# UNITED STATES PATENT AND TRADEMARK OFFICE

APPLICATION NO.	FILING DATE	FIRST NAMED INVENTOR	ATTORNEY DOCKET NO.	CONFIRMATION NO.
10/821,860	04/12/2004	Federico Cabrele	713-1121	1818

**Office Action Summary**

## **DETAILED ACTION**

Vernot:

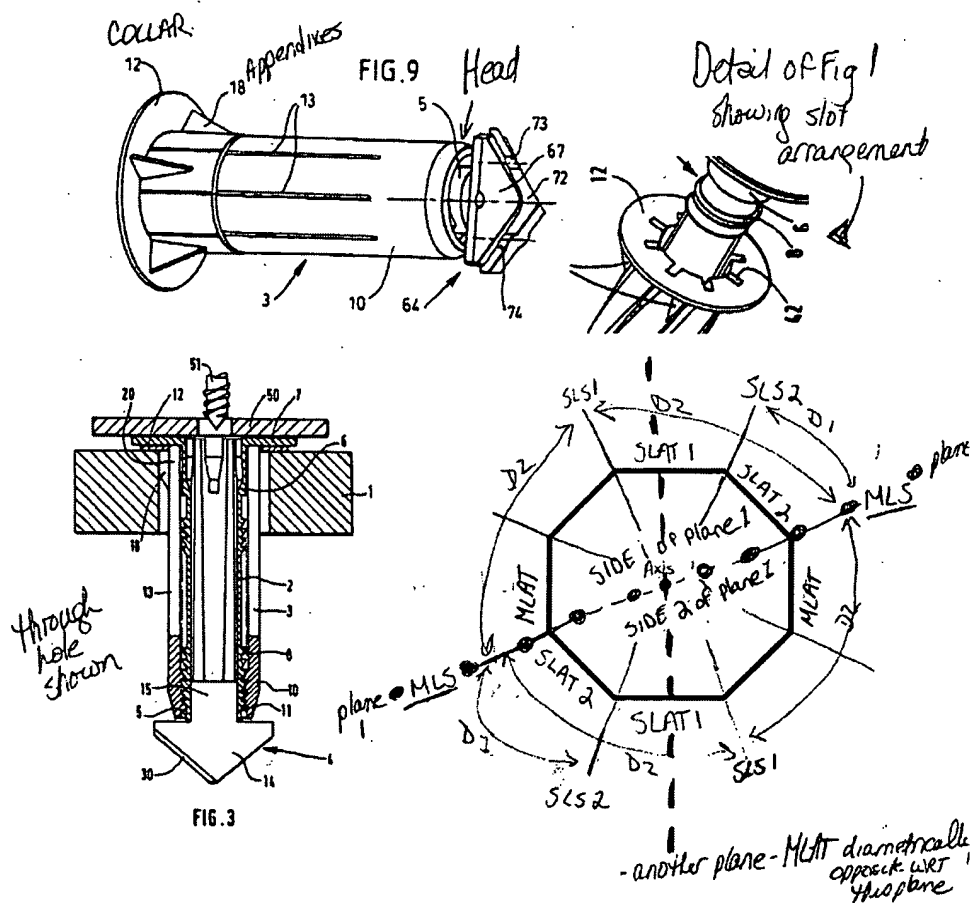
Re claims 1, 4: Vernet shows a screw anchor (3) with a deformable (expandable -abstract) central portion in which main longitudinal slots (MLS) (4 of the slots labeled "13") are formed, and further comprising secondary longitudinal slots (SLS) (the remaining 4 of the slots labeled "13") formed in said central portion. Examiner notes that 4 of the slots (13) are considered main (MLS) and the balance are considered secondary (SLS). The main longitudinal slots MLS extend essentially parallel to a plane on which a longitudinal axis of the screw anchor lies, and define deformable main

Currently the embodiment of Fig 9 is being applied since it is clearer. However, note col 3 line 66 - col 4 line 2, which explicitly states that the slots 13 are in planes which may be inclined with respect to the axis OR which pass through the axis as in Fig 3.

However, Fig 9 shows this most clearly, and note that col 5 lines 12-18 specifies that the only difference in the first and 2<sup>nd</sup> embodiments is the piercing means of the pin body -- the sleeve {anchor} are the same. However, Vernet does not disclose a substantially serrated profile on the main or secondary longitudinal anchoring tongues.

Explanation of marked up drawing: Pairs of main longitudinal slots (MLS) define main longitudinal anchoring tongues (MLAT) (strip between two "13's". There are 8 equally-spaced slots "13" (see detail of Fig 1 below) - examiner has labeled an octagon below, with each corner representing a slot, with which slots are considered main MLS and which are considered secondary SLS.

Re claim 8: Referring to the numbering by examiner of the octagonal shape, representing the collar with 8 slots of Vernet, there are 4 SLS arranged in 2 pairs that are arranged in mirror image relationship with each other, and the SLS of each pair are parallel.

Re claims 10-12: a head with a collar at a first end, said collar with annular flange (12) coaxial with longitudinal axis as shown in Fig 9 above. Projecting appendices (18) are shown as equally spaced and integral with collar and parallel to longitudinal axis. There is a head (10) at opposite end.

Re claim 14: Deformable main longitudinal anchoring tongues (MLAT) are arranged diametrically opposite one another with respect to the longitudinal axis of the anchor, and secondary longitudinal anchoring tongues (SLAT) are arranged in essentially mirror image pairs in which each pair is arranged diametrically opposite the longitudinal axis. (see marked up drawing above). However, Vernet does not disclose

FIG. 1

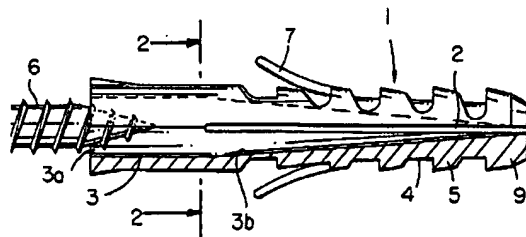
Fischer et al teach an expanding screw anchor 1 having a longitudinal slots 2 forming main longitudinal anchoring tongues (see Fig 1 below). These tongues have a substantially serrated profile, which is described in col 3 lines 13-19 as advantageous:

outer surface of the fixing plug 1. Teeth 5 are formed on the cylindrical outer surface of the fixing plug 1 between the notches 4. The teeth dig into soft material as the fixing plug<sup>15</sup> is expanded, and in hard building materials they produce corresponding frictional force at the wall of the drilled hole as a result of undergoing plastic deformation.

Fischer et al teach an expanding screw anchor 1 having a longitudinal slots 2 forming main longitudinal anchoring tongues (see Fig 1 below). These tongues have a substantially serrated profile, which is described in col 3 lines 13-19 as advantageous:
